CHART STANDARDIZATION & PAPER CHART WORKING GROUP (CSPCWG)

CSPCWG Letter: 03/2012

Subject: Draft revision of S-4 Section B-300 to B-330 – Round 2

CONSOLIDATED RESPONSES TO CSPCWG LETTER 03/2011**S-4 SECTION B-300 TO B-330 – ROUND 1**

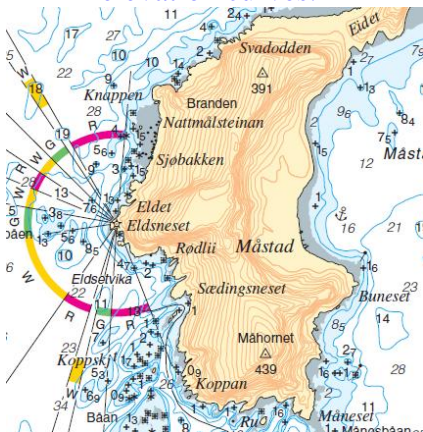
300.2 'User Needs. Despite the increasing reliance for positioning placed on global navigation satellite systems (GNSS), both its continued vulnerability (eg to interruption) and the good practice of using independent methods to confirm position are such that it is still important to chart sufficient topographic detail to enable position fixing by traditional methods'.

NO Comment: This is a very long and complicated sentence that should be rewritten.

Chairman: accepted; rewording attempted.

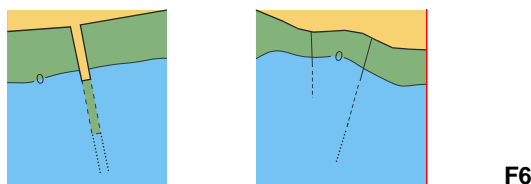
Comment: DID: please replace text in 5011 version with italics
